### ADDENDUM NO. 1

<b>Issue Date:</b>	March 5, 2024
<b>School / Facility Name:</b>	DeLand High
<b>Project Name:</b>	Softball Field Lighting
<b>Owner’s Project No.:</b>	2448067

<b>Engineer’s Representative:</b>	Adrian W. Baus, PE, RCDD
<b>Engineer’s Project No.:</b>	2023-130

Engineer Adrian Baus	
DESIGNED BY AWB	DRAWN BY MM
ISSUE DATE 01/04/2024	AS PROJECT NUMBER 2023-130
COVER SHEET	
G001

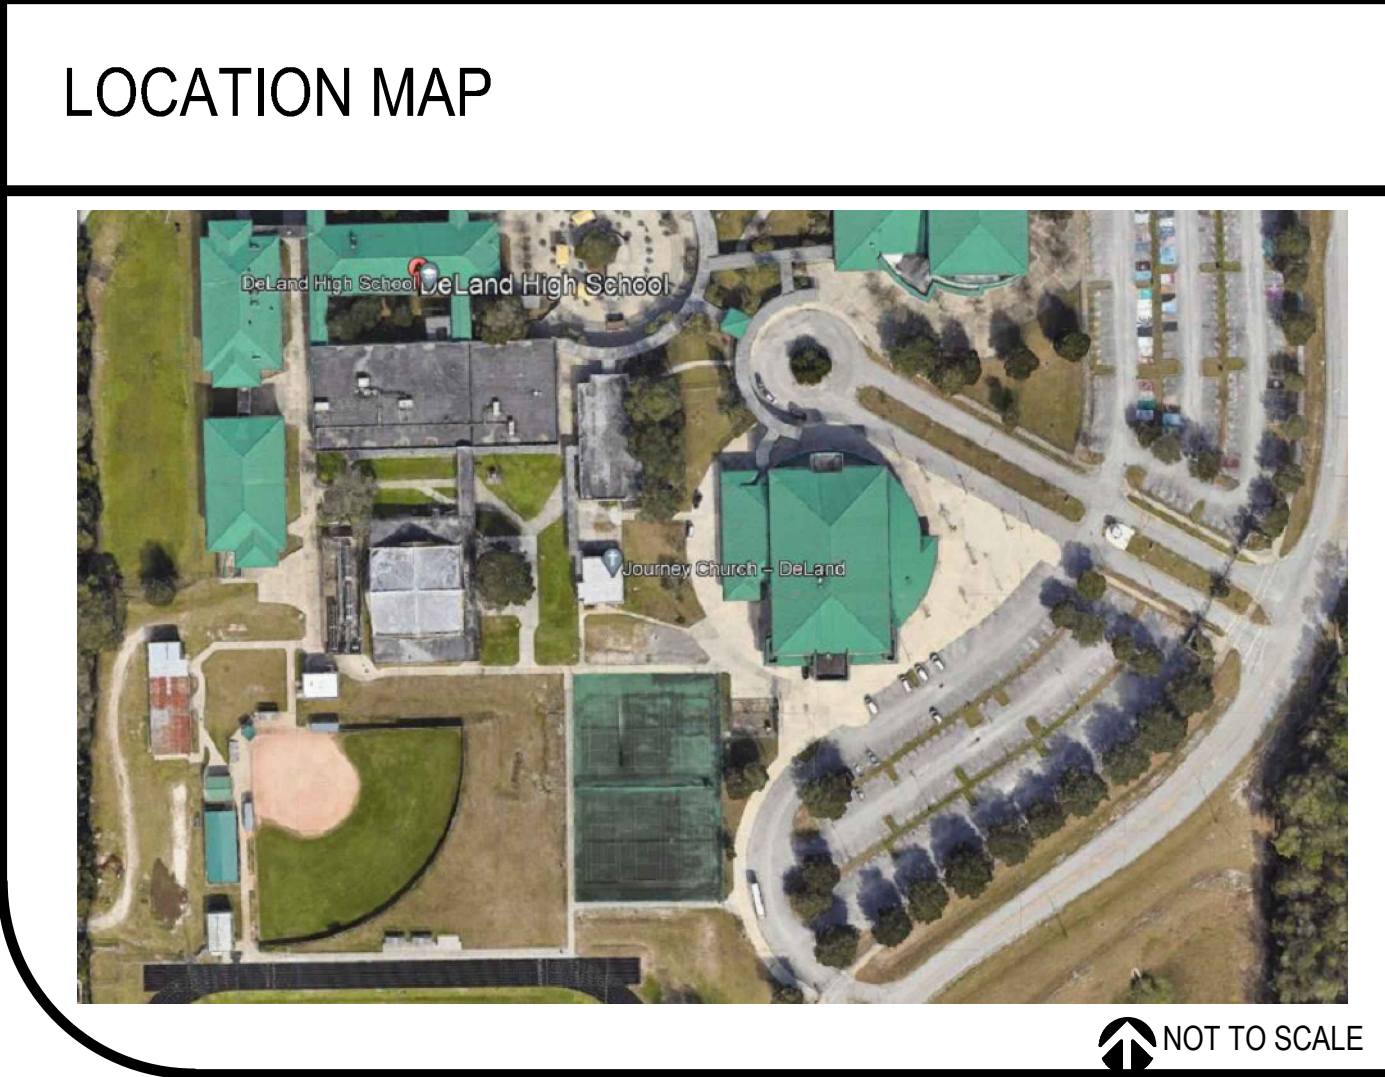
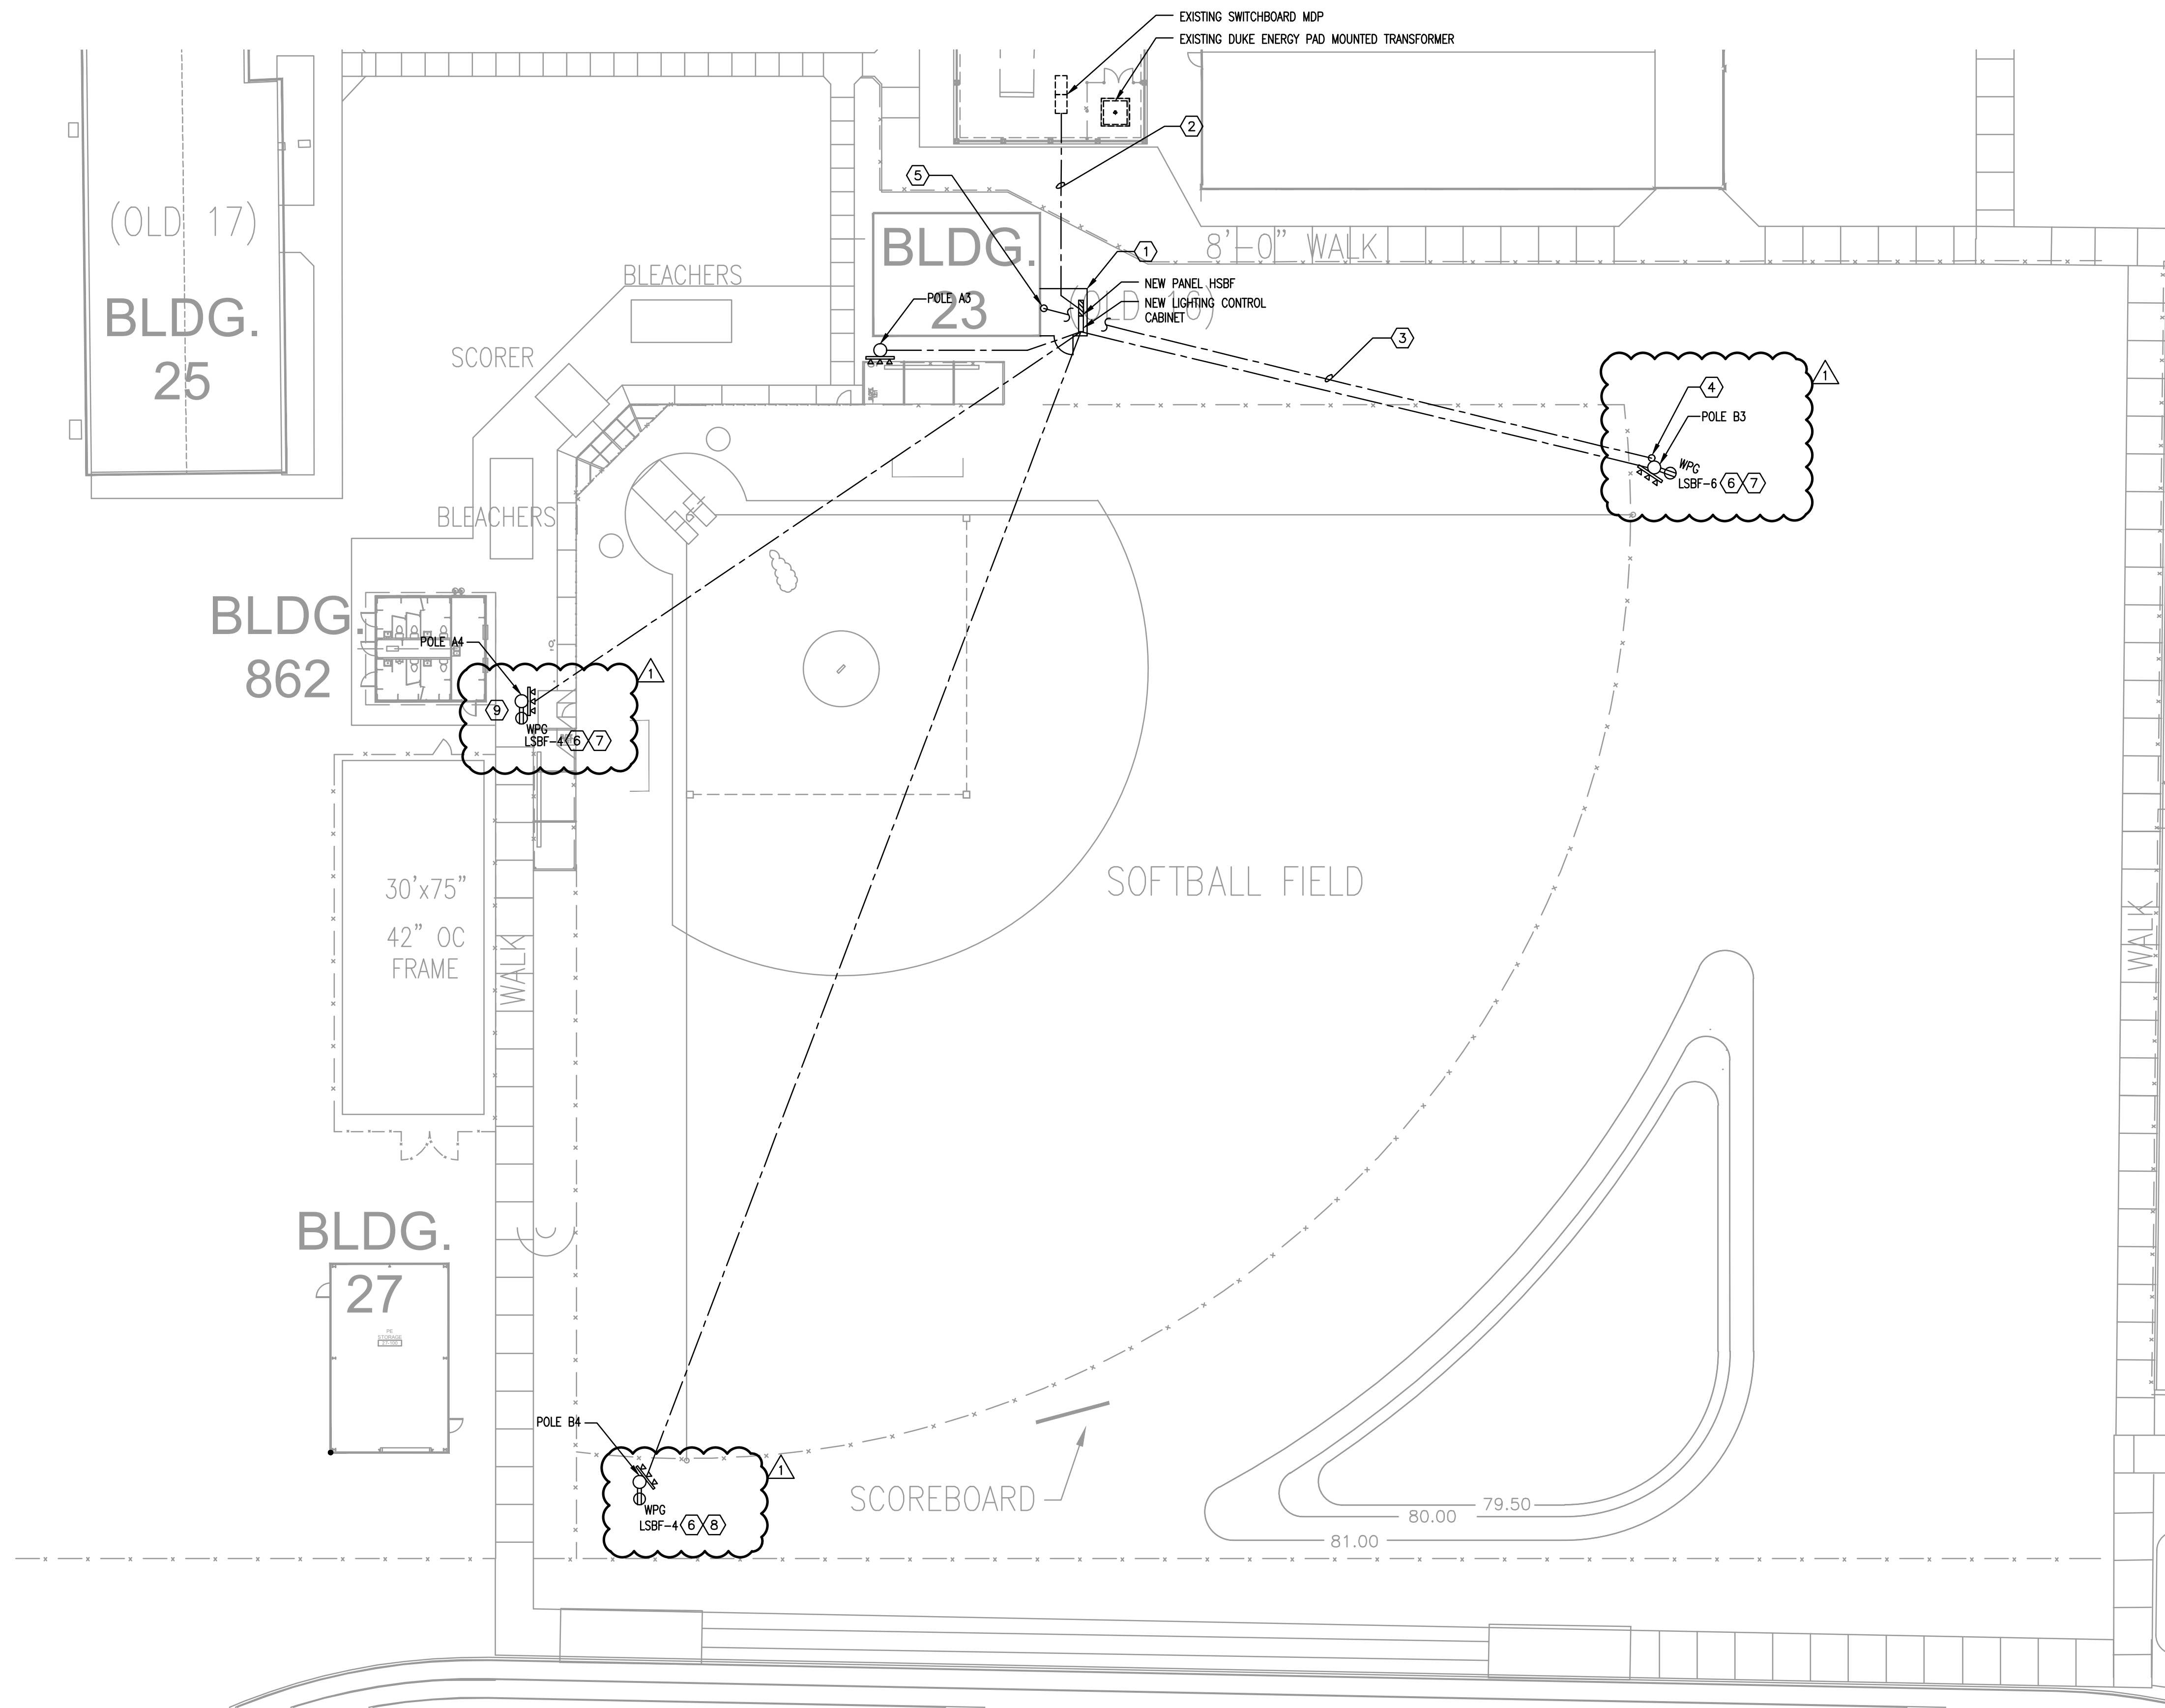
1. SHEET G001 COVER SHEET
  - a. ADD: Sheet E602 to Drawing Index.
2. SHEET E101 PARTIAL SITE PLAN – ELECTRICAL - RENOVATION
  - a. ADD: Receptacles to Poles A4, B3, and B4.
3. SHEET E601 POWER RISER DIAGRAM
  - a. ADD: Panel LSBF and Transformer LSBF to power riser diagram.
  - b. DELETE: HSBF Panel Schedule from this sheet. Schedule has been relocated to Sheet E602.
4. SHEET E602 PANEL SCHEDULES
  - a. ADD: Sheet E602 attached.

ARCHENGR OF RECORD  
 Engineer  
 Adrian Baus  
 DESIGNED BY  
 AWB  
 DRAWN BY  
 MM/AWB  
 ISSUE DATE  
 01/04/2024  
 AE PROJECT NUMBER  
 2023-130  
 SHEET TITLE  
**POWER RISER DIAGRAM AND SCHEDULES**  
 DRAWING NO.  
**E601**

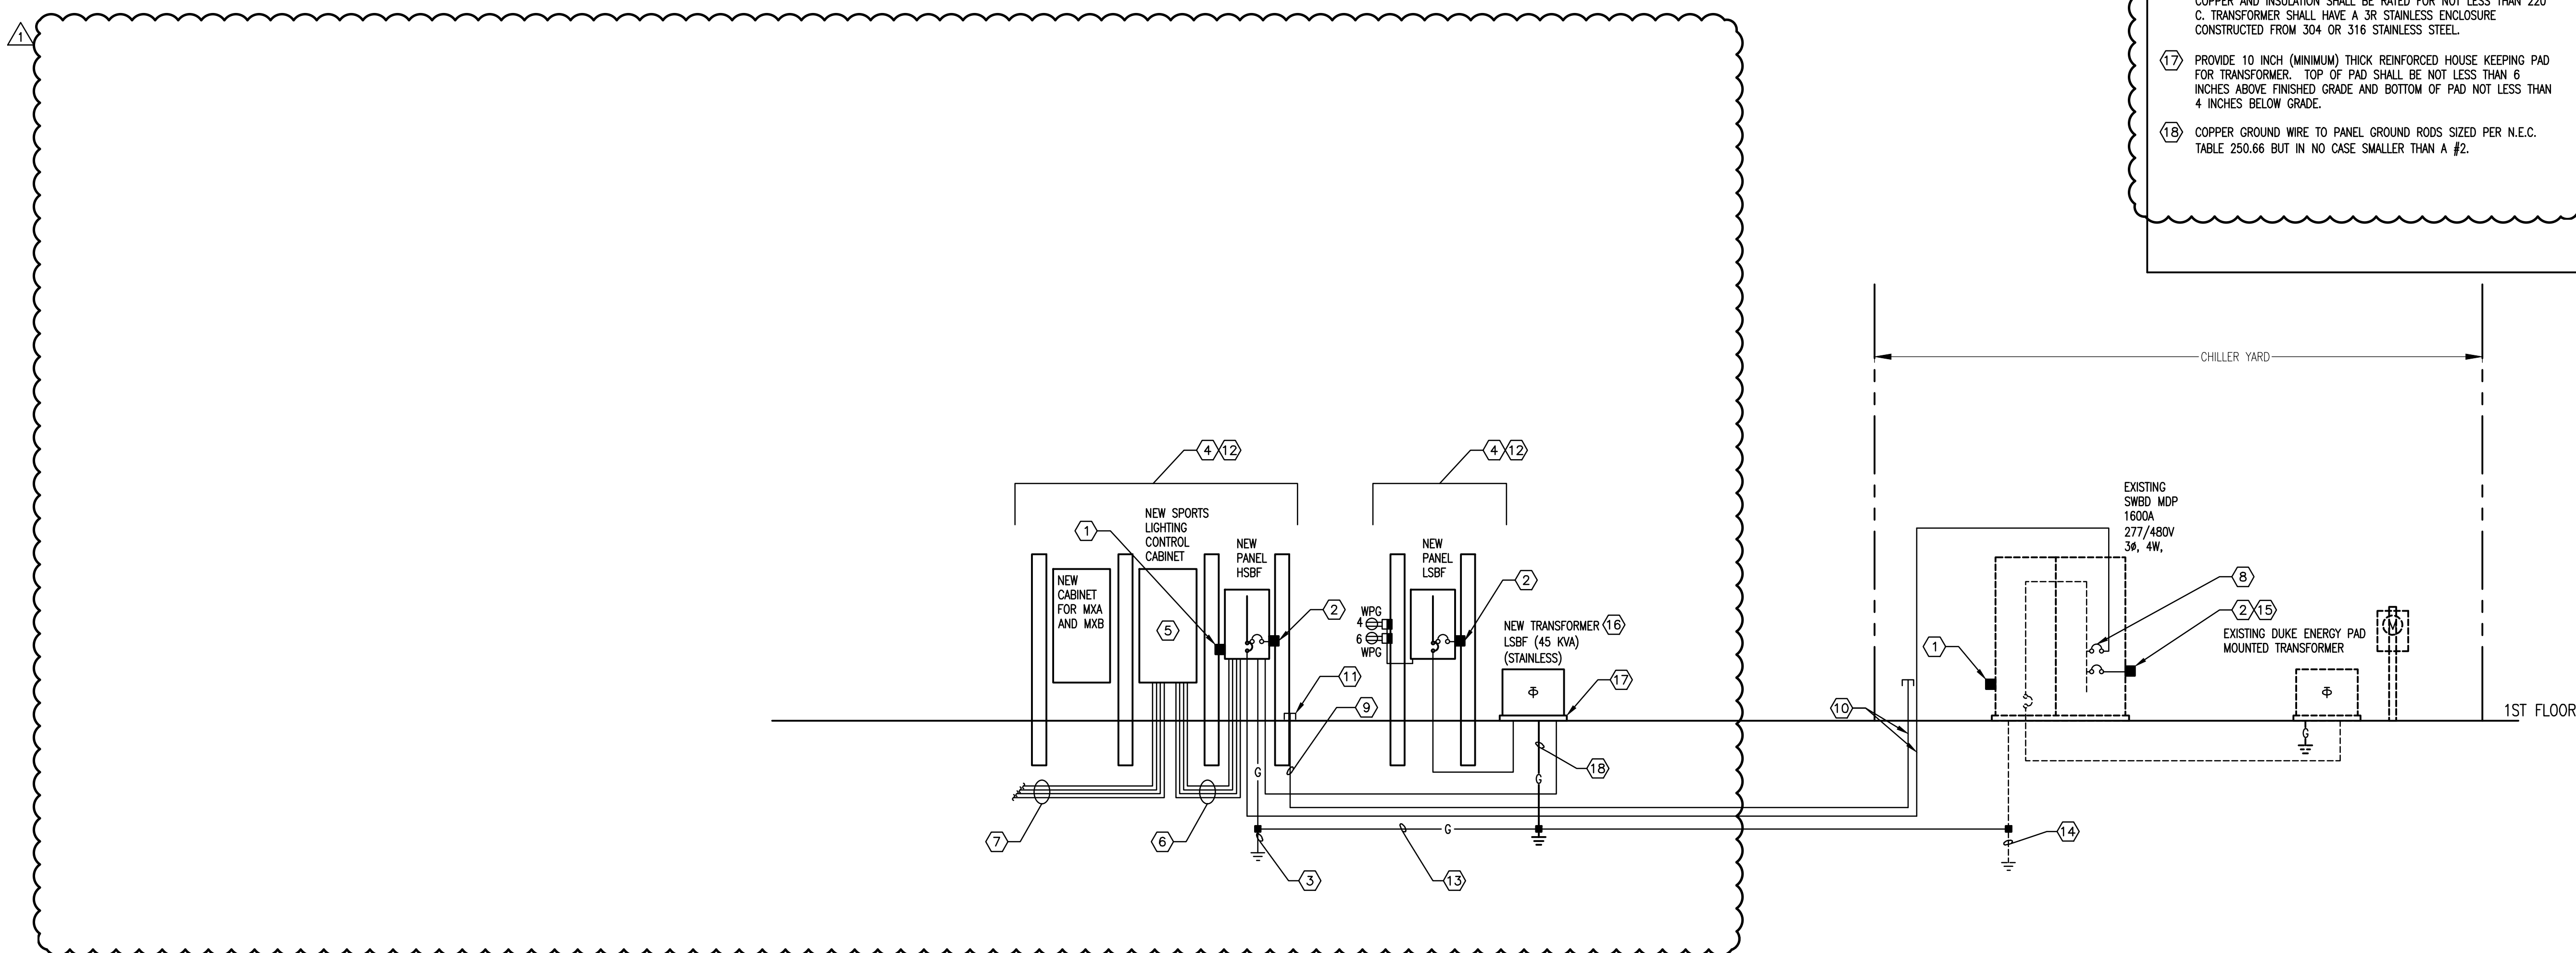
- A 45 KVA transformer with stainless steel enclosure and a corresponding 120/208 volt panel are going to be added to project via addendum. This will be used to provide 120 volt control power for the Musco Lighting Control and power for pole mounted receptacles.

- PROVIDE NEW CIRCUIT BREAKER FOR NEW SURGE PROTECTION DEVICE.
  - STEP DOWN TRANSFORMER. 480V, 3Ø PRIMARY. 120/208V, 3Ø, 4W SECONDARY; 150' C RISE. WINDINGS OF TRANSFORMER SHALL BE COPPER AND INSULATION SHALL BE RATED FOR NOT LESS THAN 220' C. TRANSFORMER SHALL HAVE A 3R STAINLESS ENCLOSURE CONSTRUCTED FROM 304 OR 316 STAINLESS STEEL.

- PROVIDE 10 INCH (MINIMUM) THICK REINFORCED HOUSE KEEPING PAD FOR TRANSFORMER. TOP OF PAD SHALL BE NOT LESS THAN 6 INCHES ABOVE FINISHED GRADE AND BOTTOM OF PAD NOT LESS THAN 4 INCHES BELOW GRADE.
